# Updating the RIN<sub>x</sub>OMA measurement method

Support for D1.0 comments #13-16, 518

May 13, 2024

Figure 52–7—RIN<sub>x</sub>OMA measurement setup

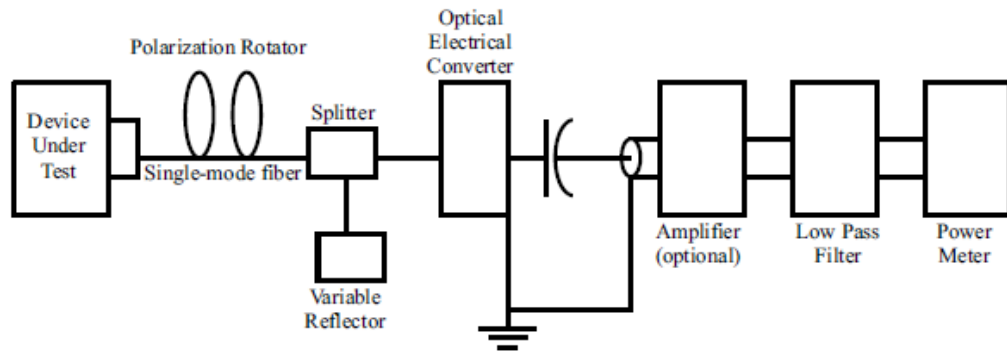
- The method of 52.9.6 specifies the use of a square wave signal and an RF power meter with 3dB bandwidth approximately equal to the signaling rate
- This method needs to be updated for 200G/L for several reasons:

- The required O/E convertors, RF detectors and amplifiers with 3dB bandwidth > 112 GHz are not readily available.
  - Some modules' transmitters can't be easily operated without modulation.

- The RIN peak frequency for DMLs scales with the signaling rate, but DMLs were not widely adopted at 100G/L and will not be used at 200G/L.
  - The RIN peak frequency for CW lasers used for 200G/L is only ~10GHz. Specifying averaging out to the signal rate underestimates average  $RIN_x$ OMA.

- Use the same oscilloscope-based reference receiver as used for TDECQ measurement with xx dB applied back reflection at worst case polarization
- Measure the RMS noise power of the 0 and 3 levels before equalization using the same pattern and sampling locations as for  $OMA_{outer}$

$RIN_{xx}OMA$ , with “xx” referring to the value for optical return loss tolerance in Table 180–7, shall be within the limit given in Table 180-7 when measured using the test pattern and sampling range specified for  $OMA_{outer}$  measurement in 180.8.4, but with applied xx dB optical reflection and the reference receiver specified for TDECQ measurement in 180.8.5. The noise is measured before the reference equalizer.

Figure 180-11—Example power levels  $P_0$  and  $P_3$  from PRBS13Q test pattern

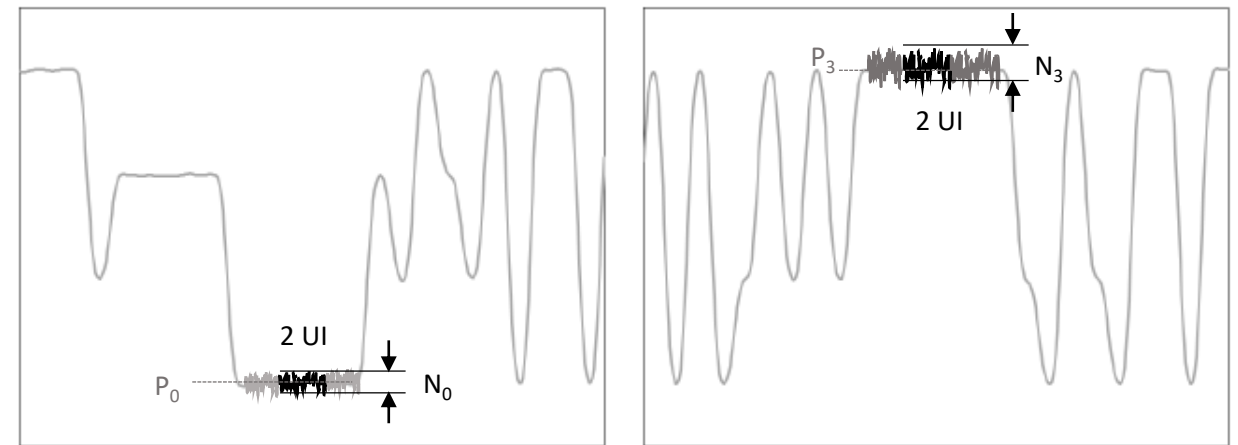
- Update the test pattern for RINxxOMA in Table 180-13 to be “4 or 6”, the same as OMAouter.
- Modify Figure 180-11 with noise as shown on slide 7. Change the description to:
  - Example power levels P0 and P3 for OMAouter measurement, and noise levels N0 and N3 for RINxxOMA measurement, from PRBS13Q test pattern.
